Observation Report

Date:	July 21, 2017	Observation Date:	July 20, 2017
Architect:	Cannon Design	Location:	Webster ISB - General
Attn:	Kelvin Patel	Observer:	Mike Nolte (WTA)
Gen. Contr.:	Paric	M/E/P/F Contr.:	Varies
File:	Webster University Interdisciplinary Science Bldg. WT 14127.01 (7)	c:	Jason Szachnieski & Devin Gates (Paric)

Roof- Mechanical Observations

Additional Properties for ID 001919

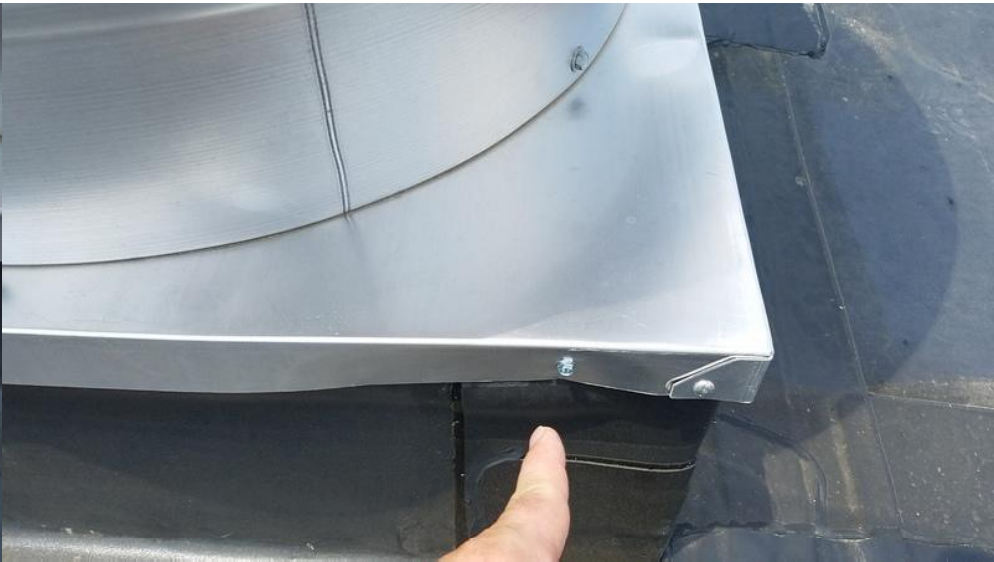
Description
EF-3: Tighten loose screws through roof curbs, add screws where missing, and seal all seams and unused screw holes water tight on roof curbs.

Additional Properties for ID 001924

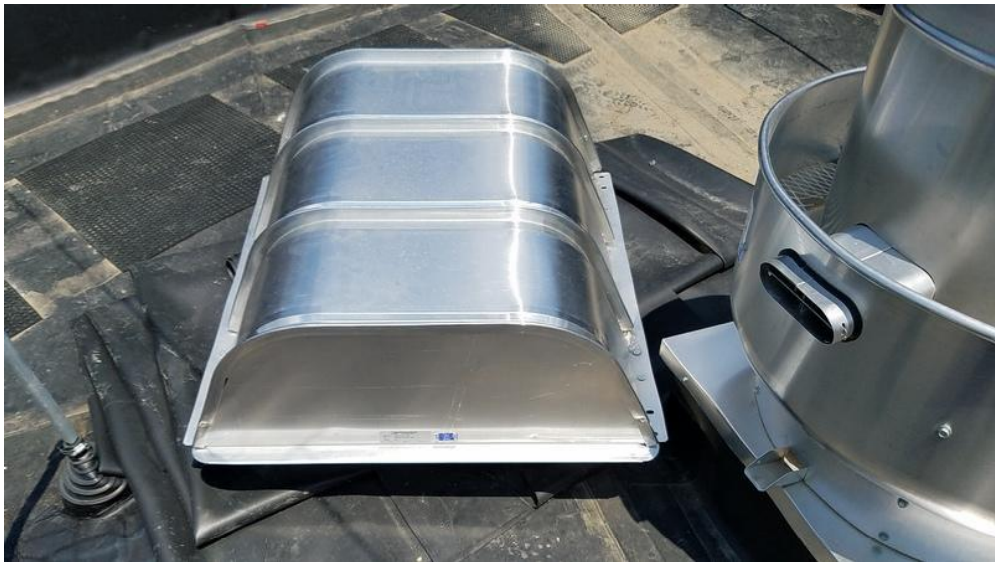
Description
H1 EAB Exhaust Roof Hood on ISB: Exhaust hood is not currently installed. However, roof curb opening is covered and existing EF located EAB attic is running with no way to discharge to the exterior of the building. This needs immediate attention.
